REMEDIATION SYSTEM EVALUATION

RAYMARK SUPERFUND SITE HATBORO, PENNSYLVANIA

Report of the Remediation System Evaluation,
Site Visit Conducted at the Raymark Superfund Site
June 7-8, 2001

Final Report Submitted to Region 3
December 19, 2001

FIGURE 1-3. CROSS SECTION OF THE GEOLOGY UNDERLYING THE RAYMARK SITE.

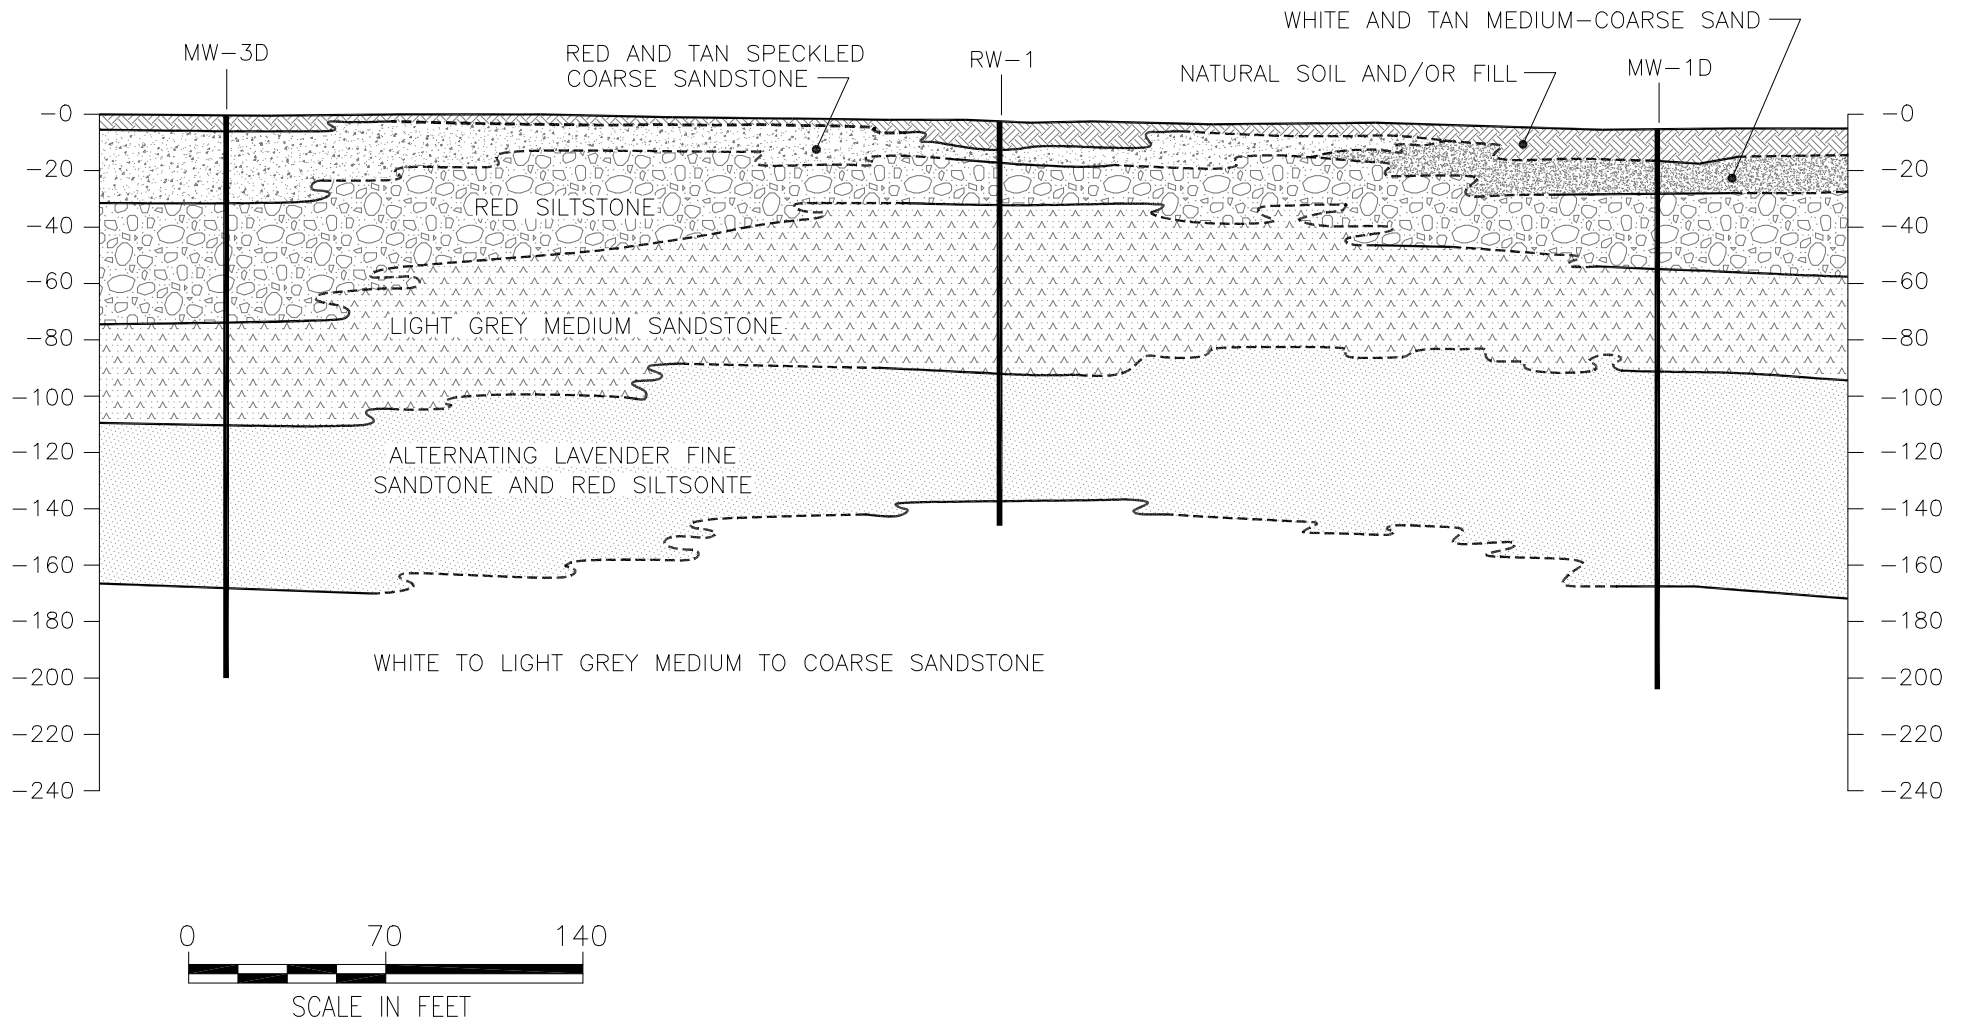
The extent of groundwater TCE contamination onsite should be further investigated as well, especially along the site boundaries. A cluster of sampling points each independently screening the stratigraphic units shown in Figure 1-3 and located midway between the MW-3 and MW-2 clusters would help delineate the plume on the western boundary of the site. This is significant given that groundwater likely flows to the west toward Pennypack Creek and Hatboro wells H-14 and H-17. Another cluster of sampling points each screening the stratigraphic units shown in Figure 1-3 and located midway between the MW-3 cluster and the rear end of the property (to the east) would help delineate the plume on the southern/western site boundary. This is also significant because Pennypack Creek turns and passes within a mile to the southwest of the site and groundwater could be flowing in that direction. These points should be added to the annual sampling program and analyzed for volatile organic compounds (VOCs).
